# Possible Production Layout

## Possible Production Layout-b

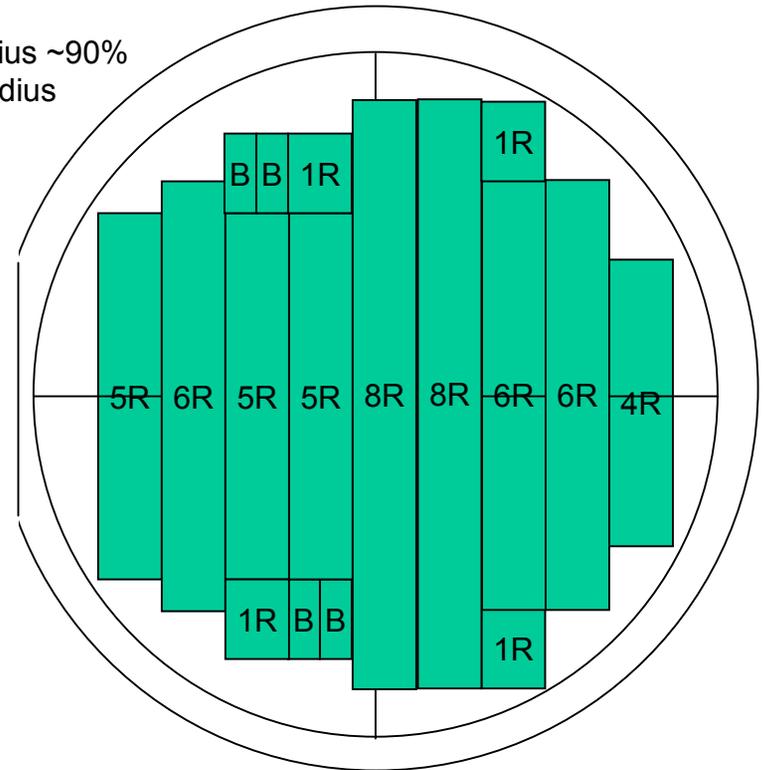
Dave,  
I would place all three 6R type sensors together to facilitate later dicing. I don't think that doing so would risk yield appreciably. Probably not at all, just puts the 8R's the other side of the center line. - Jeff
